**11 Park Village West, London,  
NW1 4AE**

**Basement Impact Assessment  
Audit**

For  
London Borough of Camden

Project No.  
14006-22

## Burland Damage Assessment - Host property Line 8

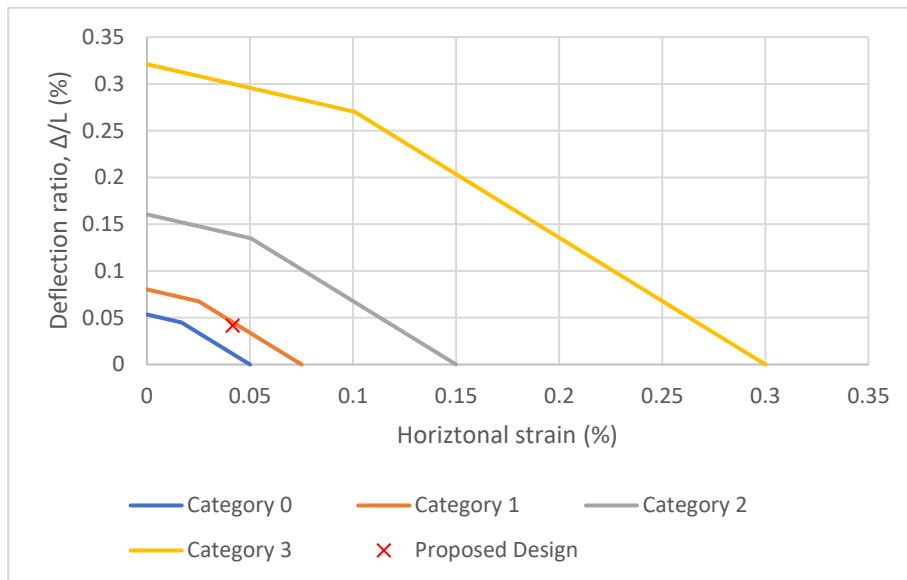
Please see attached calculation corresponding to Line 8 on the drawing plan. I've looked at our report and realised that we already cover Line 5 in the analysis – we essentially assumed a nominal offset from the excavation.

For Line D, the masonry panel is being underpinned entirely so the movement will theoretically be equal in magnitude across the length of the panel. Therefore the differential movement will be zero, thus the Burland Category will be Category 0.

Vertical Movement		
$\Delta$	2.5 mm	Estimated based on 5mm of movement over the underpin length reducing to 0mm at the garden end.
Length of building, L	6 m	
$\Delta / L$	0.04167 (%)

Horizontal Movement		
$\Delta$	2.5 mm	Assuming $\delta v_{max} / \delta h = 1$ (Fig 6.13 - CIRIA C760)
Length of building, L	6 m	
$\epsilon h$ (%)	0.04167 (%)

Gradient of line	-1.3554		-1.3554		-1.3554		-1.3554
Intrcept of line	0.06777		0.10166		0.20331		0.40663
Pass / Fail	Fail		Pass		Pass		Pass
